RE: H14-0083-26 – Yews Farm Phase 2 – Viability – Response to Thornton Firkin “Commentary Abnormals”

Abnormal Costs Commentary – Ashwood Homes Response

Land at Yews Farm, Phase 2
H14-1218-21 (Outline) & H14-0083-26 (Reserved Matters)

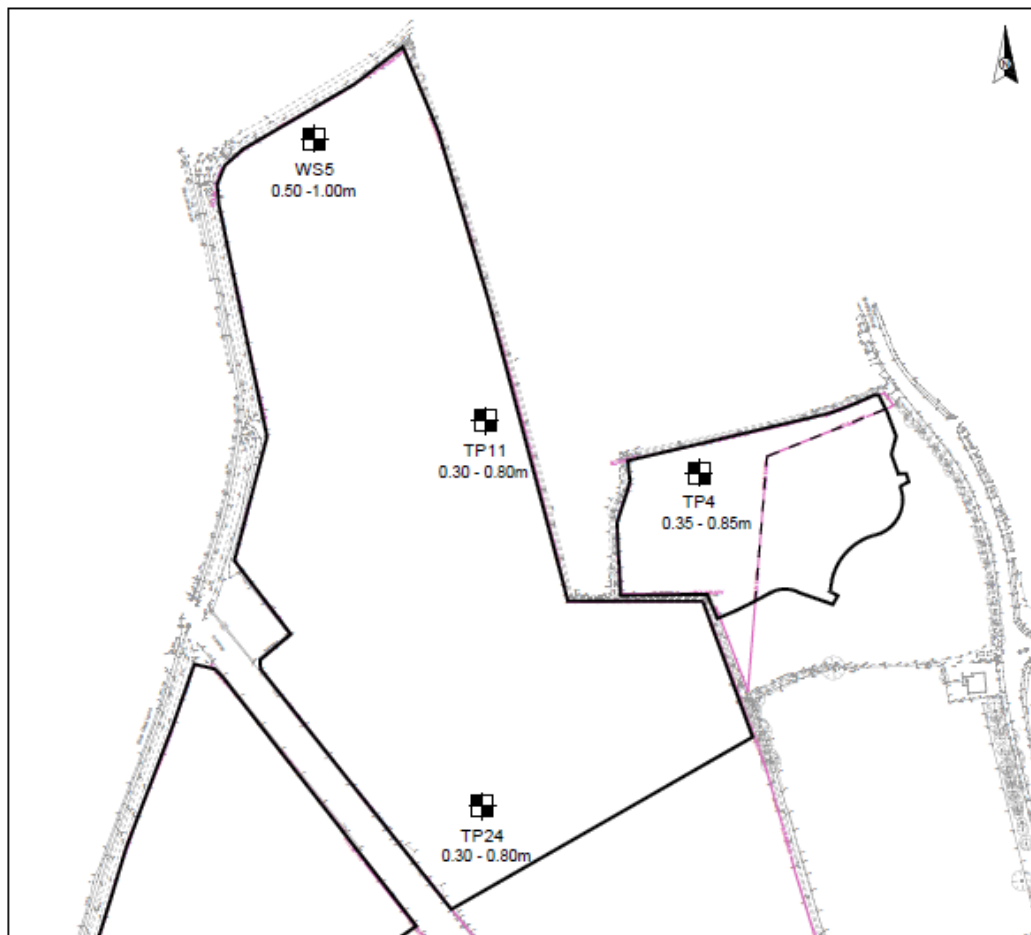
Testing prior to commencing works on the phase 2 site suggested values ranging from 0.9% to 4.7% (data and locations shown on the below plan from Ecotech.

Of the four test locations, TP4 gave the highest reading of 4.3%-4.7%, however, in practice Ashwood Homes have found CBRs consistent at sub 1.5% across the area, which is more consistent with the readings for the Phase 2 area, where test locations indicate CBRs of 0.9% to 1.9%.

Our E/O cost breakdown to assist with TF verification:

Triax Geogrid to Roads & Footpaths				
Road and footpath area 14,221 m2	14221	m2	£ 6.59	£93,737.72
				£93,737.72

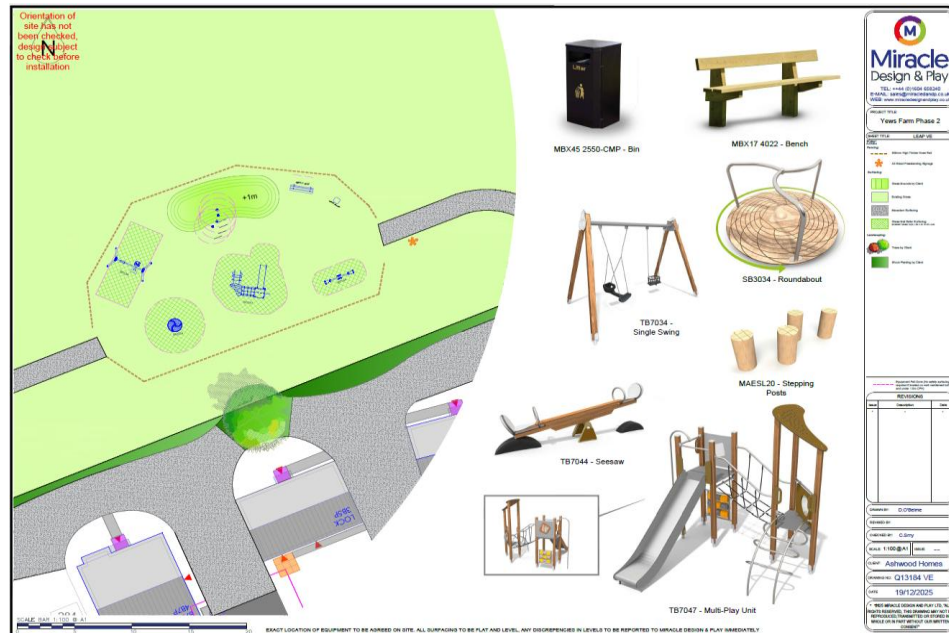
TF note that they do not have sight of the LEAP details, but that a cost of c.£30,000 would be typical for equipment and seating, and £10,990 is appropriate for the fencing.

The provisional layout and total E/O cost provision are set out below to assist with TF verification.

LEAP costs - all as per Miracle				
LEAP installation works inclusive of supply, install, management, independent inspection & adoption costs				
Play Equipment	1	item	£ 32,899.00	£ 32,899.00
Fencing works	1	item	£ 10,990.00	£ 10,990.00
Preliminaries / management of scheme	1	item	£ 6,094.00	£ 6,094.00
Inspections	1	item	£ 4,575.00	£ 4,575.00
Finishing works, to include rotovate, prep, level & turf	1	item	£ 5,000.00	£ 5,000.00
Topsoil - supply of & placement within LEAP area	1	item	£ 1,500.00	£ 1,500.00
Daily watering to turfed area for initial 2 wks	14	days	£ 150.00	£ 2,100.00
Hoggin Footpaths to access play area	70	m	£ 95.00	£ 6,650.00
				£ 69,808.00
